FISH PASSAGE CENTER

MEMORANDUM

SUBJECT: Review Comments, 2013 Draft FCRPS Supplemental Biological Opinion

Figure 1. The grey bars are the adult counts at Lower Granite Dam for hatchery steelhead from 2000 through 2012; the grey line is the geometric mean. The red line is the combined geometric mean of spawning populations for the John Day and Deschutes River basins from NMFS (2009 Appendix A).

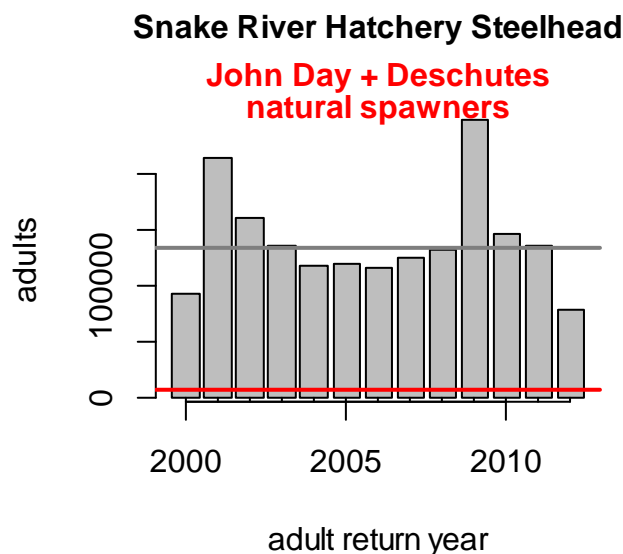
The Middle Columbia River Steelhead ESA Recovery Plan (NMFS 2009; Appendix A) concluded that a significant portion of spawners in the Deschutes and John Day River populations were out-of-DPS strays and identified out of basin hatchery steelhead strays as a limiting factor for the recovery of these subbasin populations. Increasing the numbers of transported hatchery Snake River steelhead increases the potential impact of a large Snake River hatchery steelhead population on smaller subbasin populations (Figure 1).

Figure 2. Juvenile passage date (2011) at Lower Monumental Dam of Snake River spring Chinook detected at Bonneville Dam in 2013.

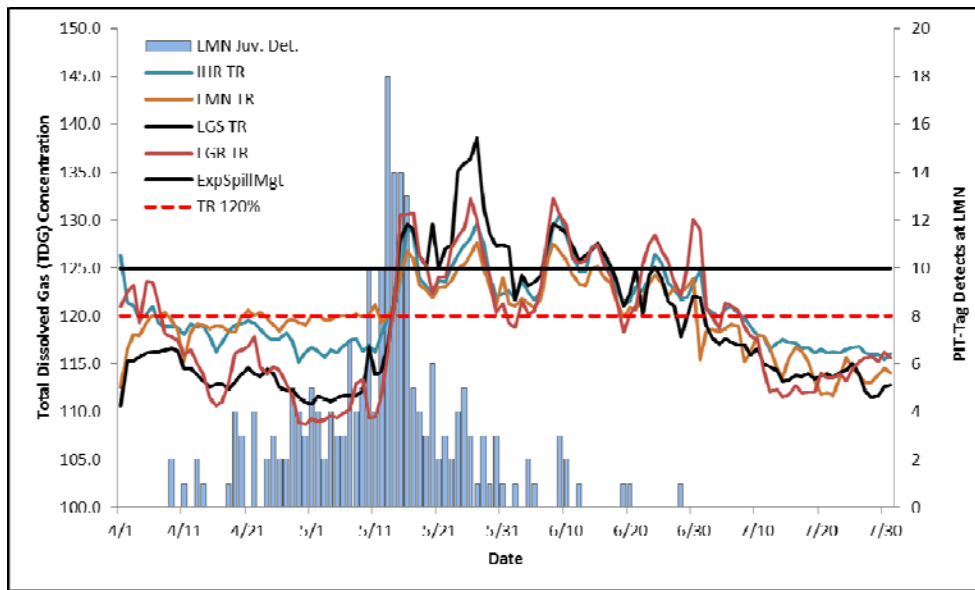
It is also important to note that implying the low adult returns from 2011 were a function of high flow and spill is not based on any analysis of the data. Figure 2 shows the juvenile passage dates at LMN for juvenile PIT-tagged Snake River yearling Chinook that were detected as adults at BON this year. While over 60% of the returning PIT-tagged adults that were detected at BON this year passed through the Snake River as juveniles when TDG was below the current States' standards of 120% in the tailrace, the other 40% were migrating in the Snake River when TDG levels exceeded 125% and, at some projects, exceeded 130%. This suggests that NOAA has made the statement in the Draft BIOP prematurely and their dismissal of the Experimental Spill Management on the basis of the low returns from 2011 is unfounded.

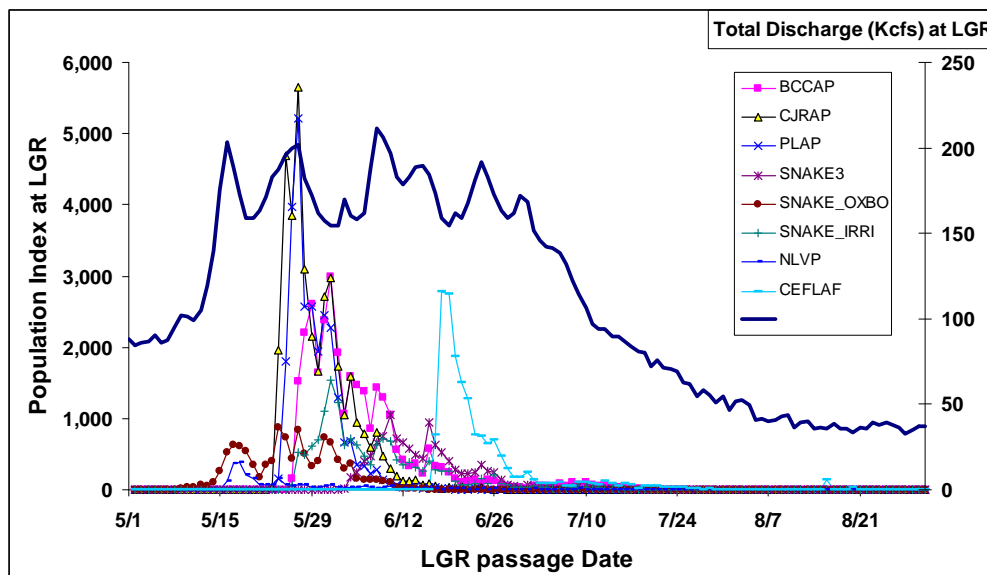
Additionally, the record returns of fall Chinook to the Snake River were predominantly (about 60% based on PIT-tagged adult fish at BON) from 2011 juvenile outmigrants returning as adults. The juvenile passage timing for subyearling migrants was earlier than average and reflected the high flow conditions (Figure 3). More than half of subyearling migrants passed through the hydrosystem during June and the first half of July, and were subjected to the high levels of TDG.

Data are too preliminary to determine what the overall SARs for Snake River fall Chinook PIT-tag groups will be, but it is likely the SARs will be relatively high compared to other recent years. In-river fish comprise a large portion of the return. Preliminary SAR analyses of six PIT-tag release groups from migration year 2011 showed five of six groups had transport/in-river-ratios less than one indicating higher return rates for in-river migrants than for transported fish. While it is too early to make any statements about conditions and the return of fall Chinook, the information is introduced here to suggest that NOAA's reliance on 2011 spring Chinook returns to reject Experimental Spill Management is unfounded particularly since fall Chinook, migrating during the peak of the high flow and spill event in 2011, are returning at notably high rates.

Figure 4. Total dissolved gas (TDG) concentration at each of the TDG tailrace monitors in the Columbia River Hydrosystem, and the experimental spill management level of 125%.

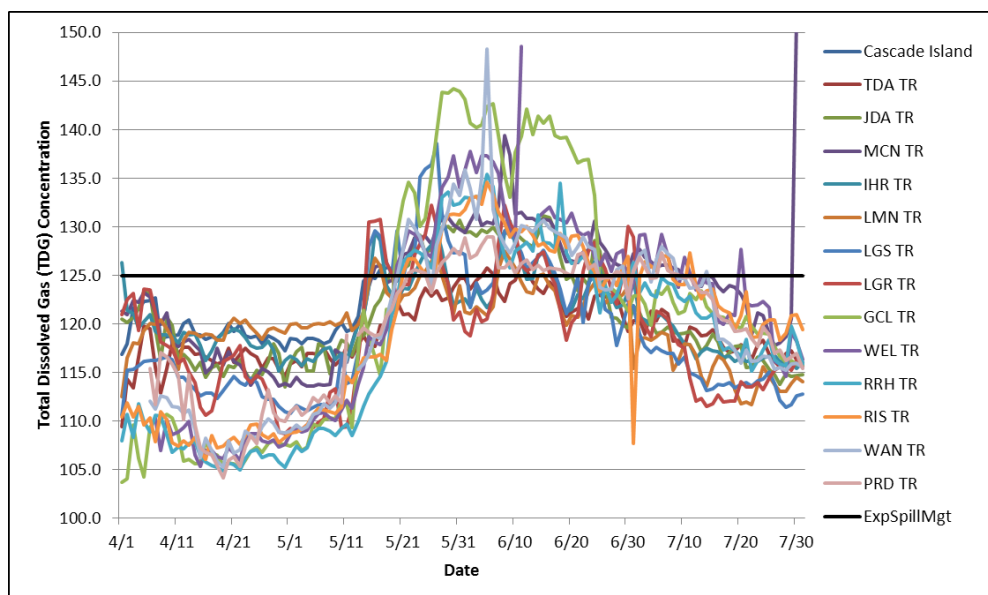
The following graph (Figure 4) shows the tailrace TDG levels that occurred through June 2011 and uses the 125% Experimental Spill Management level for reference. The 125% is the highest level considered in the Experimental Spill Management analyses for fish survival in a risk-based spill program. Consequently, comparing 2011 to what happens under a planned, voluntary spill program in Experimental Spill Management is not appropriate.

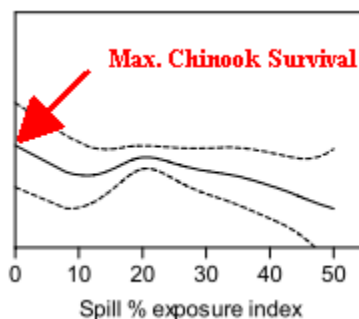
- Skalski et al. (2013) makes the comment that yearling Chinook have a maximum juvenile survival when spill is 20%, yet the model used for this same analysis predicts a maximum Chinook survival at 0% percent spill, which is obviously incorrect.

Skalski et al. (2013) references Williams et al. (2005) to note that, "For yearling Chinook salmon, survival reached a maximum at 20.6% spill." The general additive model (GAM) that Skalski et al. (2013) refers to also predicts a maximum Chinook survival when spill is zero (Figure 5). Many lines of evidence based on empirical data show that zero spill is detrimental for juvenile survival and in fact we are not aware of any other analysis available that would show that the highest possible survival would occur under zero spill operations.

Figure 6. Simple linear regressions of logit-transformed freshwater survival (S.r), ocean-adult survival (S.oe), and smolt-to-adult survival (SAR) versus average percent spill and water transit time for spring/summer Chinook salmon using data presented in Haeseker et al. (2012).

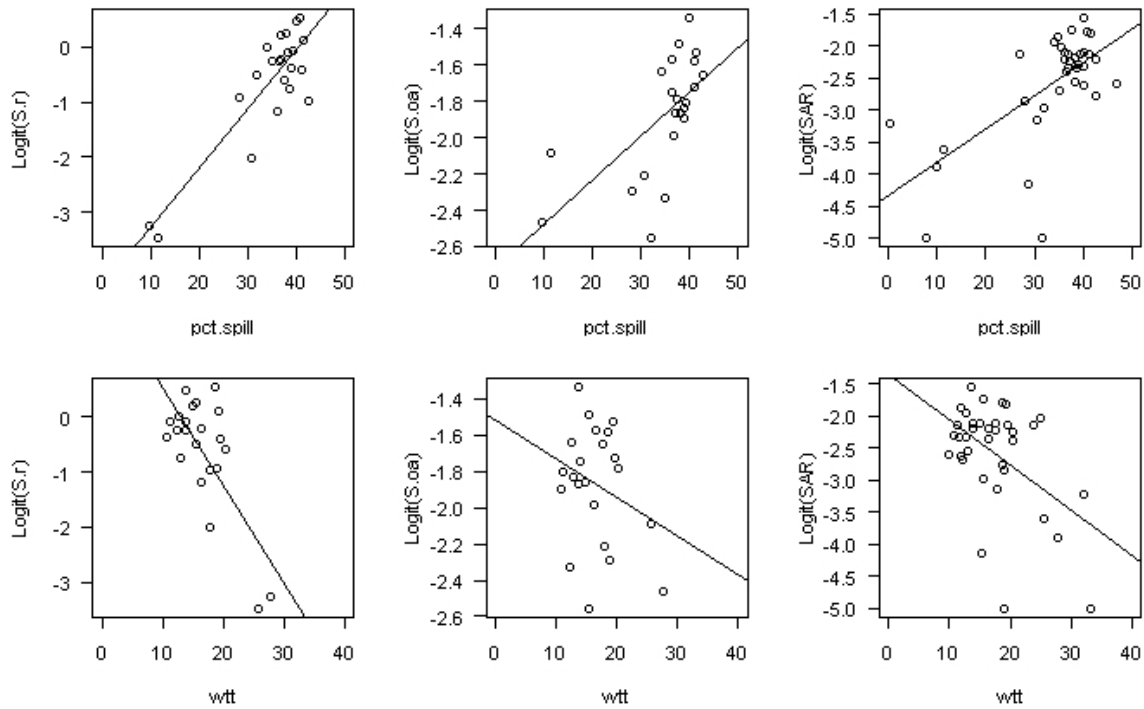
FPC used three methods to assess whether non-linear, higher-order processes or generalized additive models would have improved model fit in the data presented in Haeseker et al. (2012). First, we conducted simple linear regressions between the hydrosystem operations under management control (water transit time and average percent spill) and the stage-specific survival rates presented in Haeseker et al. (2012). These simple linear regressions suggest that there is a linear response between hydrosystem operations and freshwater survival, ocean-adult survival, and smolt-to-adult survival rates (Figures 6 and 7). These data also do not show indications of higher-order processes, optima, or thresholds. Contrary to the coarse-scale, and likely overparameterized, analysis on freshwater survival presented in Skalski et al. (2013), the data in Haeseker et al. (2012) indicate increasing survival at all life stages with increasing spill levels and reductions in water transit time (Figures 6 and 7). The data simply do not support Skalski et al.'s (2013) conclusion that survival is maximized at 35% spill levels.
